Public Hearing for WVDEP Proposed Legislative Rule 47CSR13

IN RE: PROPOSED LEGISLATIVE RULE 47CSR13

WVDEP's Response to Comments on the Proposed Rule Changes to 47CSR13

Figure 1. 2018 Long-term National Seismic Hazard Map. Source: United States Geological Survey, <https://www.usgs.gov/media/imagery/2018-long-term-national-seismic-hazard-map>

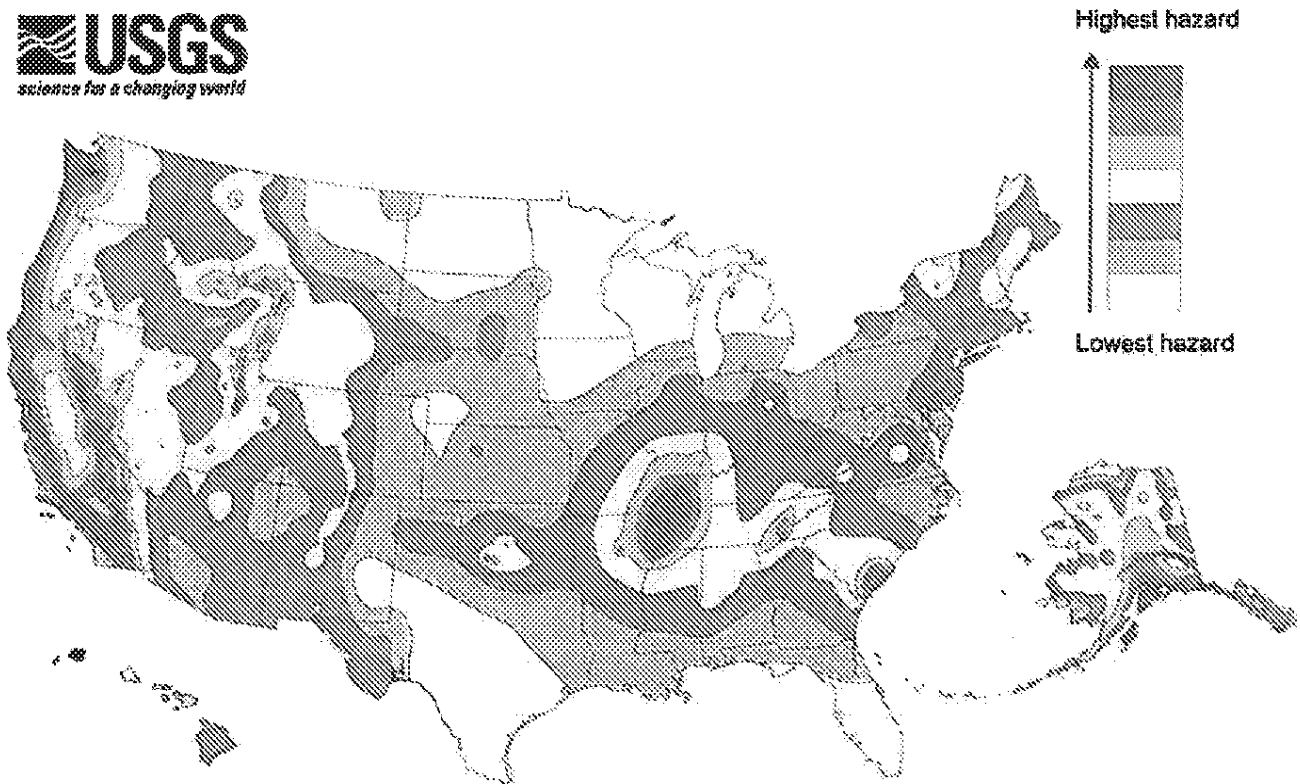
Better definition of "Seismic Risk Zones". Avoiding seismic risk is key for these projects, however the definitions used in Section 47-13-7, sec 4.a are somewhat confusing, based on our review of literature. An example map is shown in Figure 1, from the United States Geological Survey. Better understanding of the seismic risk zones and their definition is recommended, to

prevent unnecessarily precluding activity in areas that may have relevant existing industrial activity. The West Virginia Geological and Economic Survey has extensive experience in seismicity and induced seismicity in the state, and WVUEI recommends cooperative engagement with the Survey on this question, and inclusion of reference to the maps/databases used to define these Seismic Risk Zones.

Comment 2: Better definition of “Seismic Risk Zones”. Avoiding seismic risk is key for these projects, however the definitions used in Section 47-13-7, sec 4.a are somewhat confusing, based on our review of literature. An example map is shown in Figure 1, from the United States Geological Survey. Better understanding of the seismic risk zones and their definition is recommended, to prevent unnecessarily precluding activity in areas that may have relevant existing industrial activity. The West Virginia Geological and Economic Survey has extensive experience in seismicity and induced seismicity in the state, and WVUEI recommends cooperative engagement with the Survey on this question, and inclusion of reference to the maps/databases used to define these Seismic Risk Zones.
